I'm writing to provide additional input on Mercer Island Permit Application 2207-019's recent [submission response memo](#) (SUB2) and corresponding revised [plans](#). On October 25, 2022, I and my attorney, Zach Davison, submitted comments during the public comment period on the initial plan set. This letter supplements those comments in response to the revised plans submitted by the applicant on March 1, 2023.

1. Elevations shown in the revised plans are incomplete and contradictory

The diagram on Sheet C-2 (below) shows:

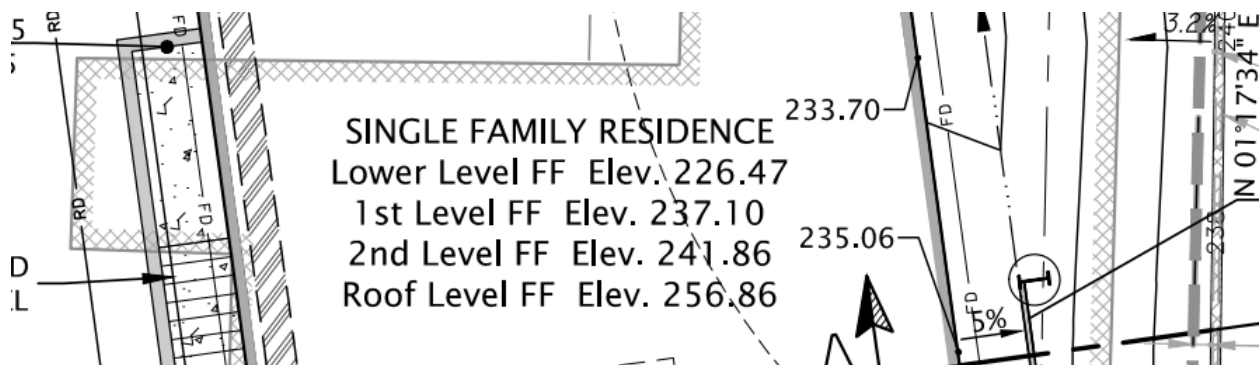
- Lower level FF of 226.47'
- 1st level FF of 237.10'
- 2nd level FF of 241.86' (only 4.7' above the 1st level FF)
- Roof level FF of 256.86'

While Sheet A3.1 (below) shows:

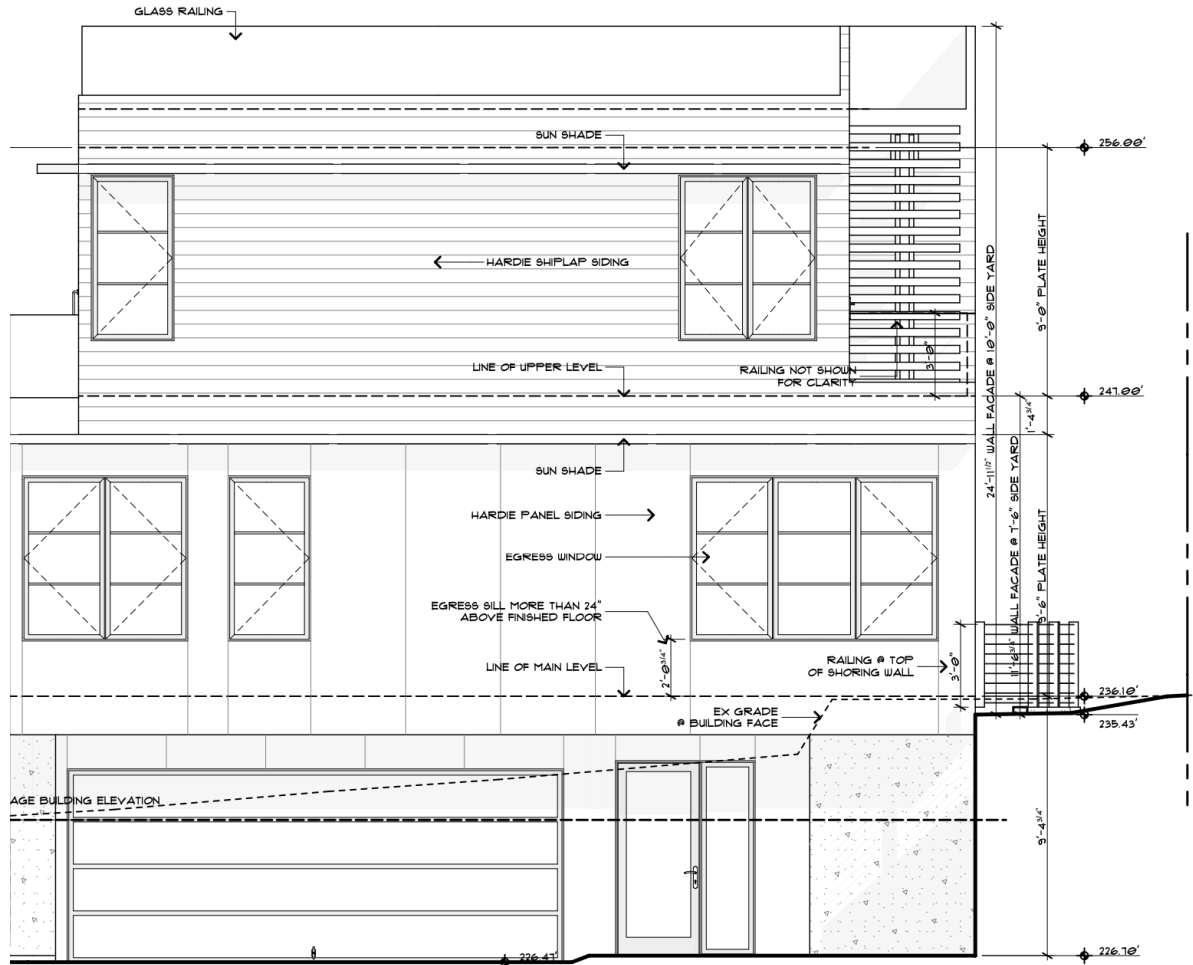
- Lower Level FF varies between 226.47' and 226.70' (differs from C-2)
- 1st Level FF of 236.10' (differs by 1.0' from C-2)
- 2nd Level FF of 247.0' (differs by 5.1' from C-2)
- Does not show Roof level FF
- Does not show elevation of the top of the railings.

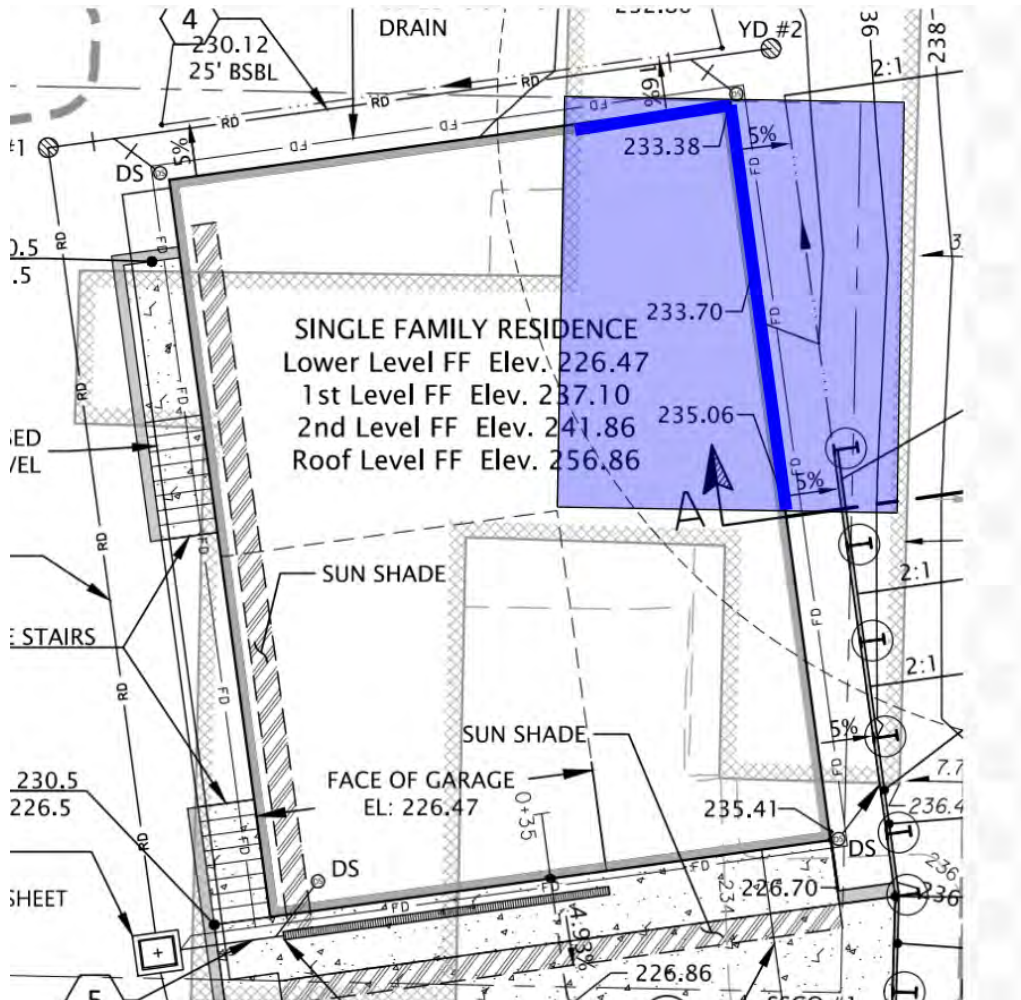
We understand the accepted City of Mercer Island interpretation of 'existing grade' is "the grade of the lot as it currently sits" more specifically the surveyed grade prior to start of this proposed project (5/27/2021).

This contradicts MICC 19.02.020(E), as described in original comments from Dan Grove and Zachary Davison.

In addition, the 5/27/21 survey shows that a substantial amount of this project (and its foundation walls) sits within an existing basement that is at a 5/27/21 grade ("2021 Grade") of

228', as shown below (the existing basement at 228' is in light blue, and the proposed foundations that sit on a current grade of 228' are in dark blue).

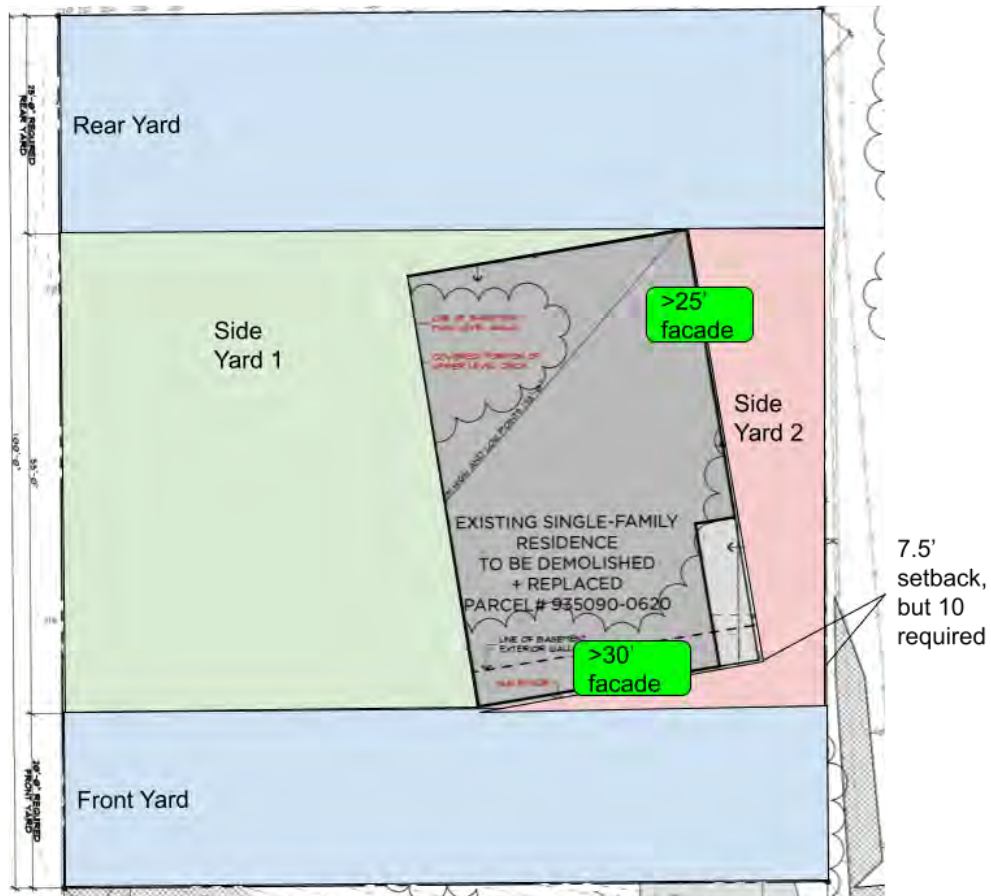
4. Maximum Building Height on Downhill Façade is shown on the South Elevation of the updated drawings and is measured at 29'-6" to the top of the wall supporting the roof framing per MICC

SUB2 incorrectly excludes the deck railing and the area at the top of the wall from the Facade Height.

By not correctly using the Existing Grade (which is lower than the Finished Grade), the height of Facade is further incorrectly computed.
